Re: Florida Power & Light Company  
St. Lucie Units 1 and 2, Docket Nos. 50-335, 50-389  
Turkey Point Units 3 and 4, Docket Nos. 50-250, 50-251

Supplemental Information to License Amendment Request to Adopt Common Emergency Plan  
with Site-Specific Annexes

**Revised Response to Request for Additional Information**

Figure B.4: Interrelationship of Emergency Response Organizations

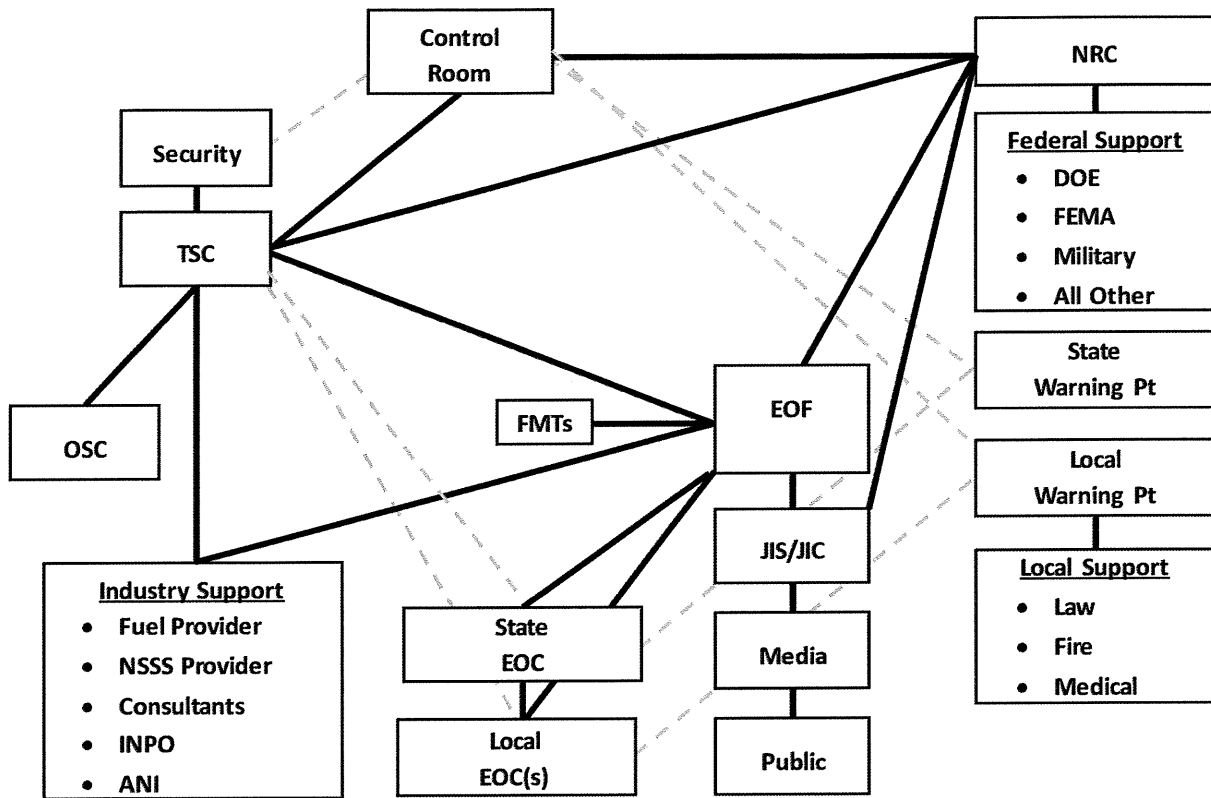
NextEra response to RAI 42 states Figure B.4 was eliminated. However, if the diagram is simply eliminated, NextEra would then have to describe the interface to meet B.4 not just delete the figure. The application did not provide sufficient justification that supports a finding that State and local organizations within the Emergency Planning Zones have been assigned, the emergency responsibilities of various supporting organizations have been specifically established, and each principal response organization has staff to respond. (RAI 42)

Provide clarification of the apparent differences between TSC and EOF interfaces between Figure B.4, "Interrelationship of Emergency Response Organizations," and the ERO responsibilities described in the proposed NextEra Common Emergency Plan.

Figure B.4 is being removed from the Common Emergency Plan as it was deemed to be complicated and unnecessary.

Figure B.4 has been reinserted into the Common Emergency Plan with a link indicating the interface between the TSC and State and local EOCs.
